REPORT OF ALTERATIONS TO DESIGNATED RESOURCE

Site Number/Address: 729 Mathews St.

Laurel School National Register Historic District

ISSUED: August 3, 2020

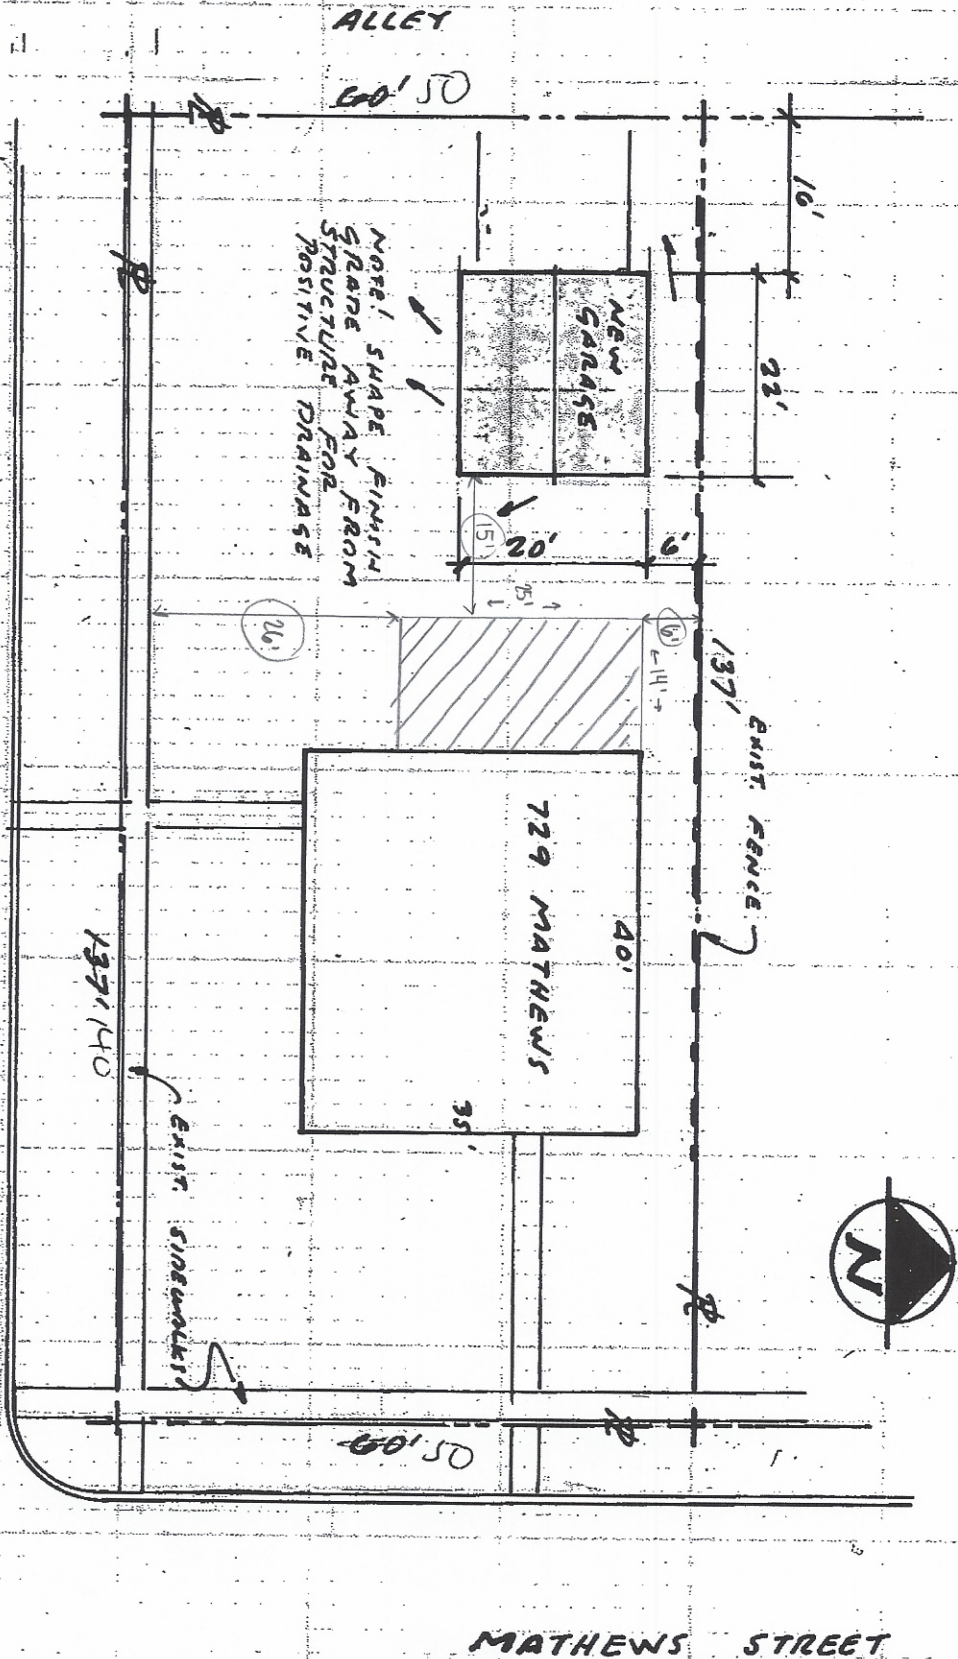
- Construction of a new patio cover onto the rear (west) elevation of the main house.

Applicable Code Standard	Summary of Code Requirement and Analysis (Rehabilitation)	Standard Met (Y/N)
SOI #1	<i>A property will be used as it was historically or be given a new use that requires minimal change to its distinctive materials, features, spaces, and spatial relationships;</i> Property will remain in residential use.	Y
SOI #2	<i>The historic character of a property will be retained and preserved. The removal of distinctive materials or alteration of features, spaces, and spatial relationships that characterize a property will be avoided.</i> The patio addition is being added to the rear of the property. It will be visible from public rights-of-way due to the property being a corner lot but is similar in overall form to historic kitchen and “mud-room” additions on other homes in the historic district. The fascia that will be removed to anchor in the supports are not character-defining.	Y

SOI #3	<p><i>Each property will be recognized as a physical record of its time, place, and use. Changes that create a false sense of historical development, such as adding conjectural features or elements from other historic properties, will not be undertaken.</i></p> <p>The new patio is simple in design and being placed on modern, rounded caissons at the edge of a modern concrete patio. It should remain recognizable as new construction.</p>	Y
SOI #4	<p><i>Changes to a property that have acquired historic significance in their own right will be retained and preserved.</i></p>	N/A
SOI #5	<p><i>Distinctive materials, features, finishes, and construction techniques or examples of craftsmanship that characterize a property will be preserved.</i></p> <p>The rear of the property does not appear to contain any character-defining features, other than the lapboard siding. The covered patio addition will be removing the fascia to allow for anchoring the patio roof, but this feature is not character-defining on the rear elevation.</p>	Y

SOI #9	<p><i>New additions, exterior alterations, or related new construction shall not destroy historic materials that characterize the property. The new work shall be differentiated from the old and shall be compatible with the massing, size, scale, and architectural features to protect the historic integrity of the property and its environment.</i></p> <p>The new patio is consistent in overall form and size with other rear additions in the historic district. Its modern construction as a patio will allow it to be differentiated clearly as new construction while being generally compatible with the overall character of the neighborhood.</p>	Y

SOI #10	<p><i>New additions and adjacent or related new construction will be undertaken in such a manner that, if removed in the future, the essential form and integrity of the historic property and its environment would be unimpaired.</i></p> <p>The patio addition includes minimal structural anchors onto the existing home that can be easily reversed and removed in the future.</p>	Y
----------------	--	----------
